## COUNCIL ASSESSMENT REPORT – MODIFICATION APPLICATION

### SYDNEY EASTERN CITY PLANNING PANEL

<b>PANEL REFERENCE &amp; DA NUMBER</b>	[PPSSEC-445] – DA/631/2018/A
<b>PROPOSAL</b>	Section 4.56 Modification to an approved Seniors Housing Development including reduction from 164 beds (comprising 108 Residential Aged Care Units and 56 Independent Living Units) to 99 beds (comprising 41 Independent Living Units, 44 Residential Aged Care Units and 14 Assisted Living Units), removal of gates, introduction of visual break-up of the built-form along Mons Avenue elevation, removal of porte-cochere and basement access from Mons Avenue, consolidated loading and basement vehicle access from Malabar Road, conversion of Residential Aged Care Facility (RACF) rooms, provision of a rooftop communal open space and relocation of café.
<b>ADDRESS</b>	Lot 101 DP 776582, 481-499 Malabar Road, MAROUBRA
<b>APPLICANT</b>	Catholic Healthcare Limited
<b>OWNER</b>	Catholic Healthcare Limited
<b>MOD LODGEMENT DATE</b>	5 November 2025

<b>RECOMMENDATION</b>	Approval
<b>DRAFT CONDITIONS TO APPLICANT</b>	No
<b>SCHEDULED MEETING DATE</b>	1 April 2026
<b>PLAN VERSION</b>	Plan Set - Dated 26 September 2025 (Revisio

Figure 4: Site Plan - Proposed modification

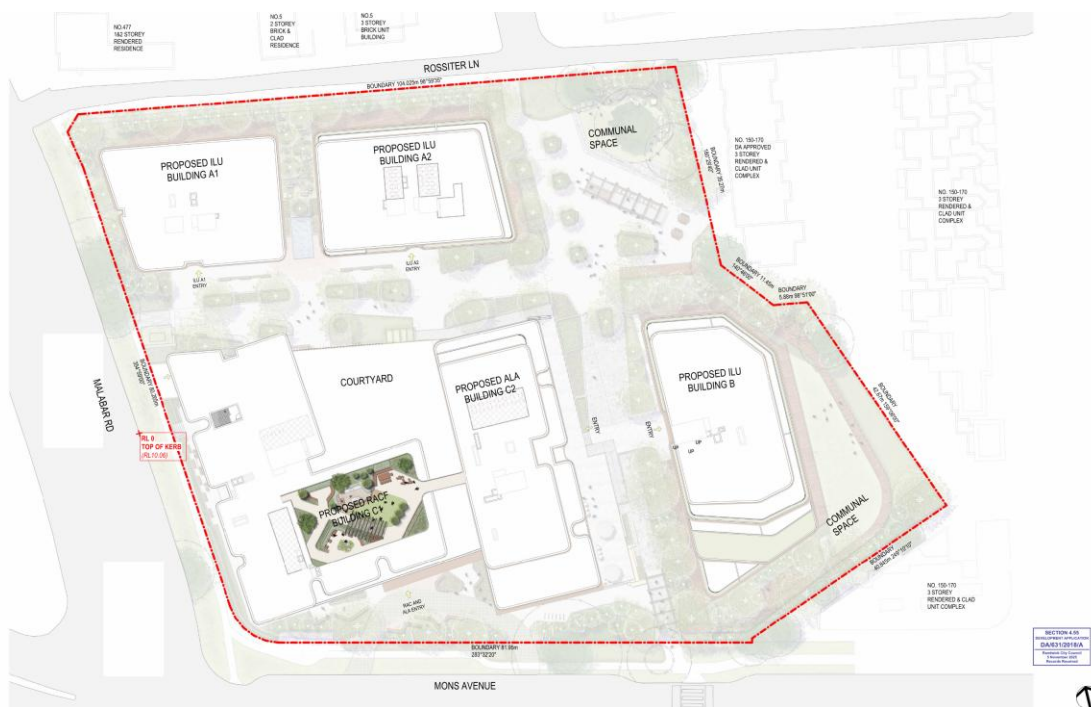
The Section 4.56 modification to the approved Seniors Housing development includes: reduction from 164 beds (108 RACF and 56 ILUs) to 99 beds (41 ILUs, 44 RACF rooms and 14 ALUs), removal of gates, visual break introduced along the Mons Avenue elevation, removal of the porte-cochere and basement access from Mons Avenue, consolidated loading and basement vehicle access from Malabar Road, conversion of RACF rooms to a RACF/ALU mix, provision of a recessed rooftop communal open space, relocation of café, relocation of floorspace centrally within the site and provision for four (4) business identification signs.

Figure 24: Shadow Diagrams on 21 June

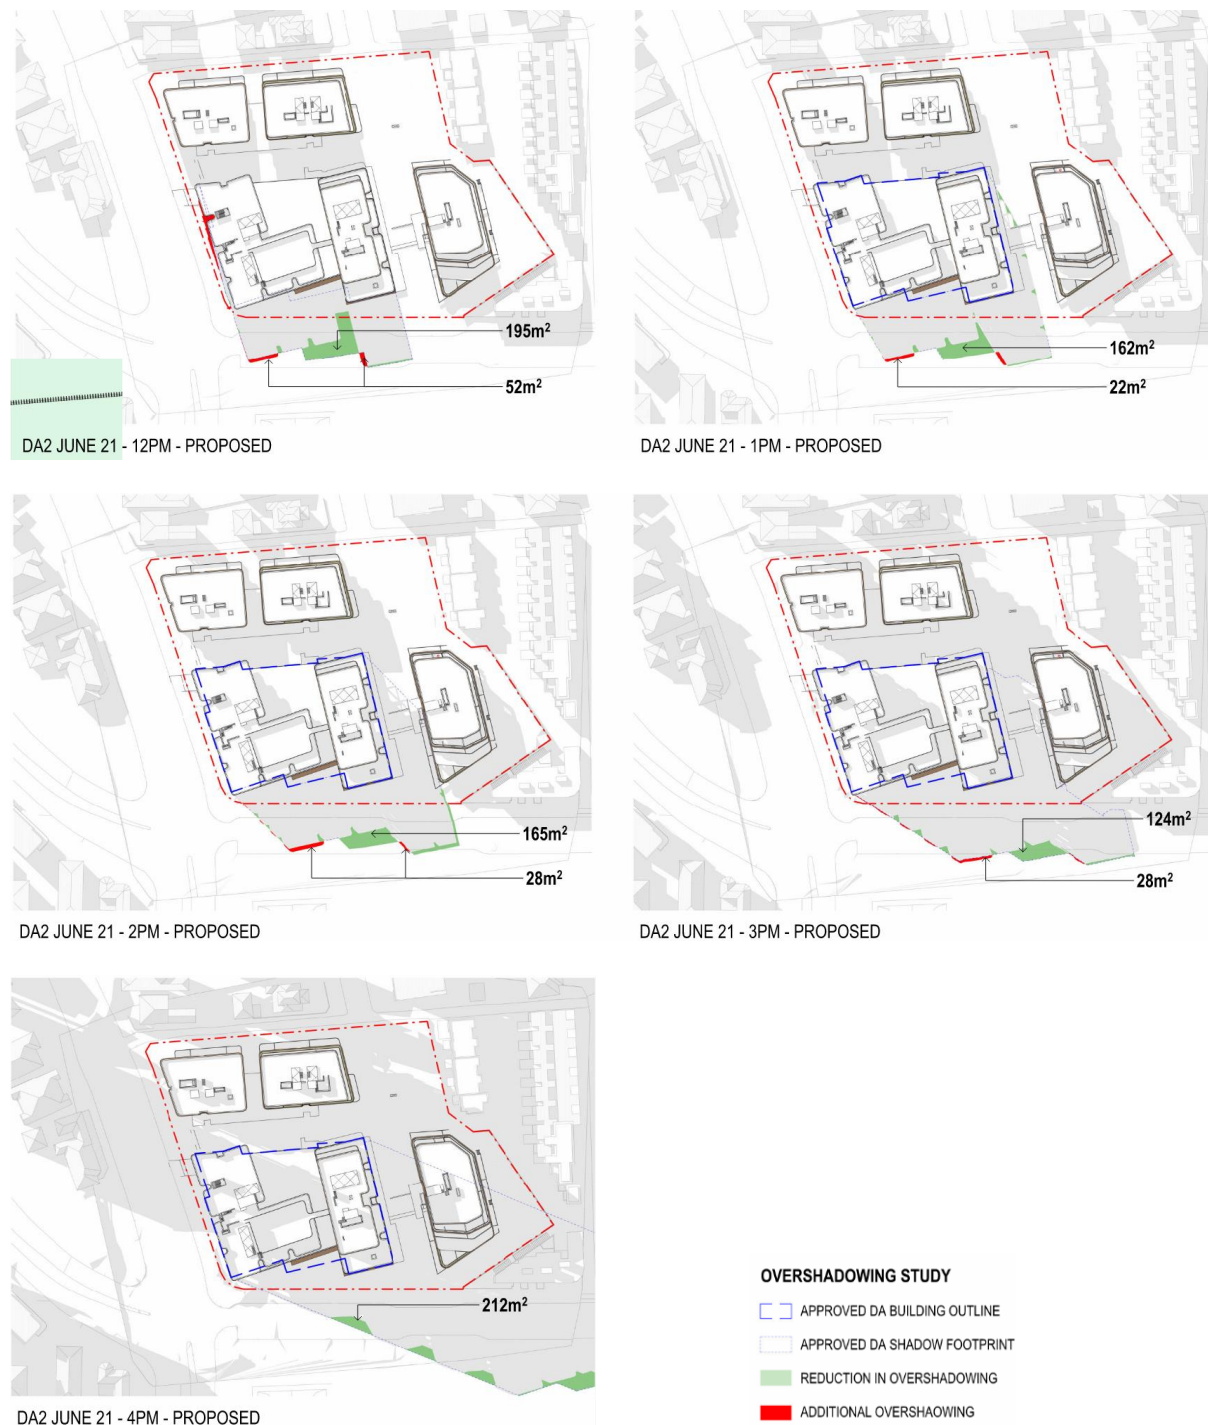
Solar access and overshadowing impacts are acceptable. The modification achieves measurable net reductions in overshadowing relative to the approved scheme and maintains compliant solar access for dwellings and communal open space. Sensitive receivers are not adversely affected. Refer to shadow diagrams below in Figure 22.

Figure 25: Section Building B and 150-170 Mons Avenue (Source: Group GSA Design)

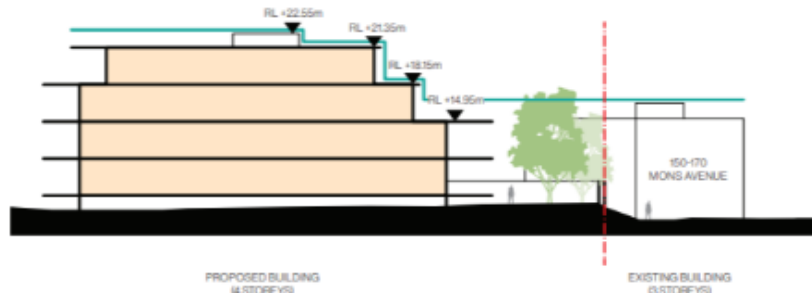
#### 04 | Pulling Back from the Neighbour (Building B)

The built form steps back from Mons Avenue and the neighbours at 150-170 Mons Avenue to reduce the perceived scale of the building from the street and its neighbour, and to respect the amenity of its neighbour by minimising overshadowing.

Figure 35: Proposed external façade Elements

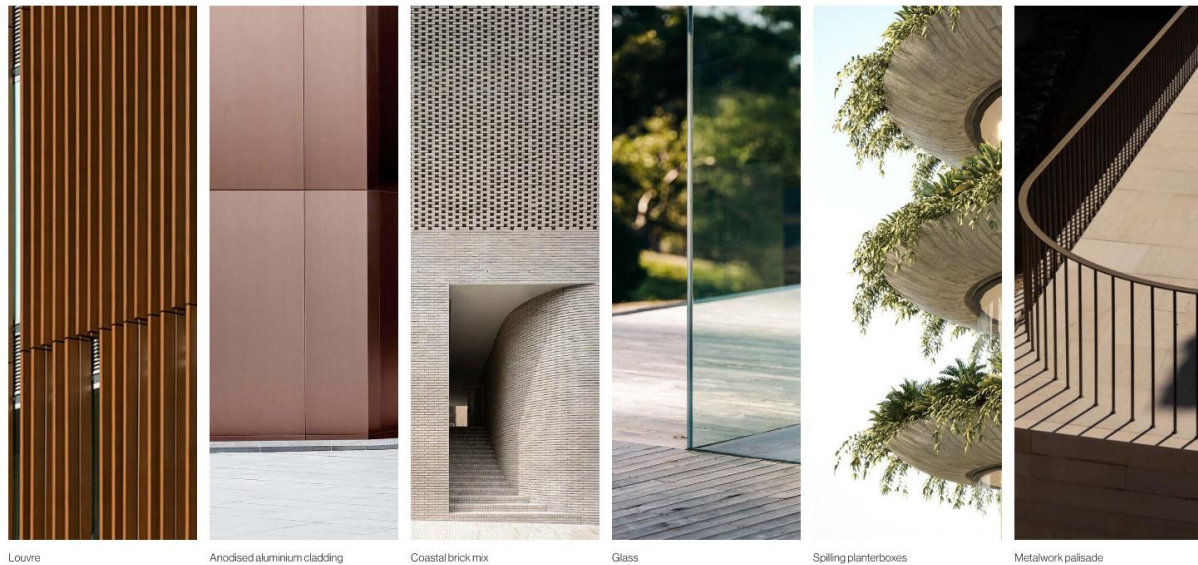
Resolution: The concerns in relation to the C1–C2 bridge have been addressed through a lighter, recessive, well-detailed link and the external colours/finishes/materials schedule is acceptable for coastal durability, visual cohesion and amenity reasons. In addition, new Condition 2A is imposed that requires the development is carry out in accordance with the external colours, materials and finishes as contained in the Response to Submissions report.
